## "STORMTRAP" RE-DESIGN OF STRUCTURE FOOTING & SUBGRADE TREATMENT LENGTH PROFILE VIEW

## "STORMTRAP" RE-DESIGN OF STRUCTURE FOOTING & SUBGRADE TREATMENT WIDTH PROFILE VIEW

APRIL 2018 OB NUMBER: 2018-0055

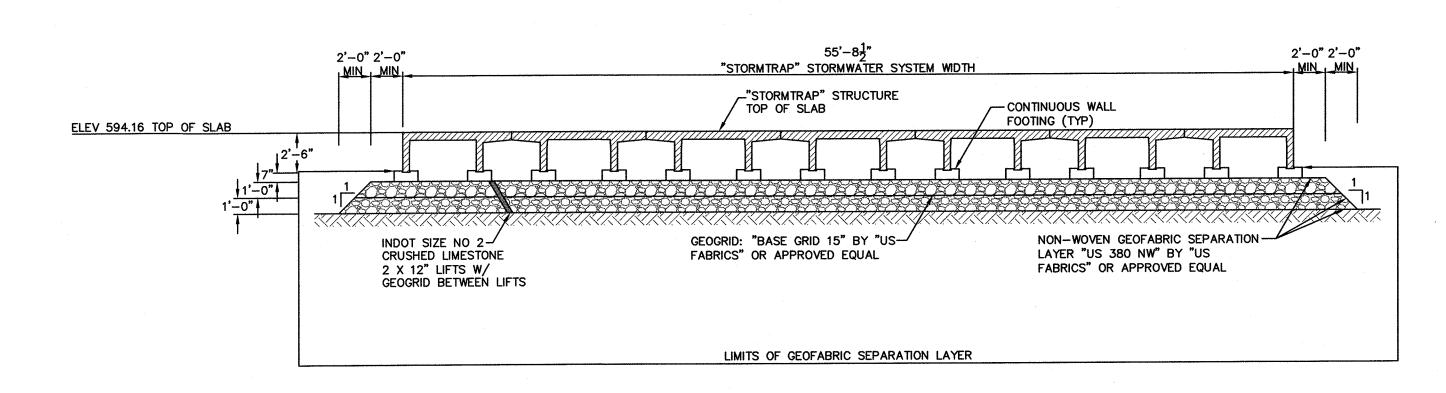
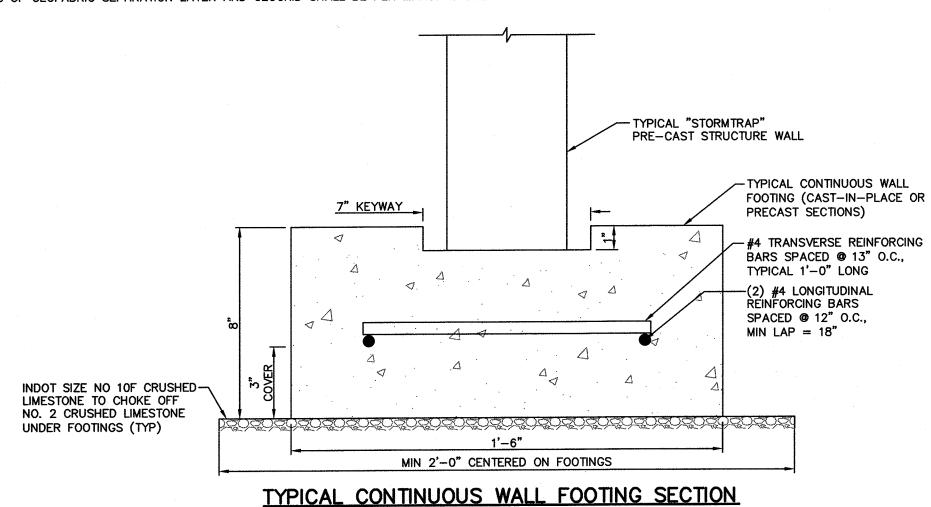
1. DETAILS OF THE RE-DESIGN OF "STORMTRAP" SUBGRADE TREATMENT ARE SCHEMATIC.

4. CONTINUOUS WALL FOOTING CONCRETE SHALL BE INDOT CLASS A CONCRETE, CONSTRUCTED IN ACCORDANCE WITH INDOT STANDARD SPECIFICATIONS SECTION 702 AND SHALL ACHIEVE A MINIMUM 3,500 PSI COMPRESSIVE STRENGTH IN 28 DAYS. REINFORCING STEEL SHALL BE DEFORMED GRADE 60 UNCOATED, CONSTRUCTED IN ACCORDANCE WITH INDOT STANDARD SPECIFICATION SECTION 703.

8. LONG AXIS OF GEOGRID APERTURES SHALL BE PLACED PARALLEL TO LONG AXIS OF "STORMTRAP" STRUCTURE. 9. OVERLAPS OF GEOFABRIC SEPARATION LAYER AND GEOGRID SHALL BE PER MANUFACTURER'S RECOMMENDATIONS.
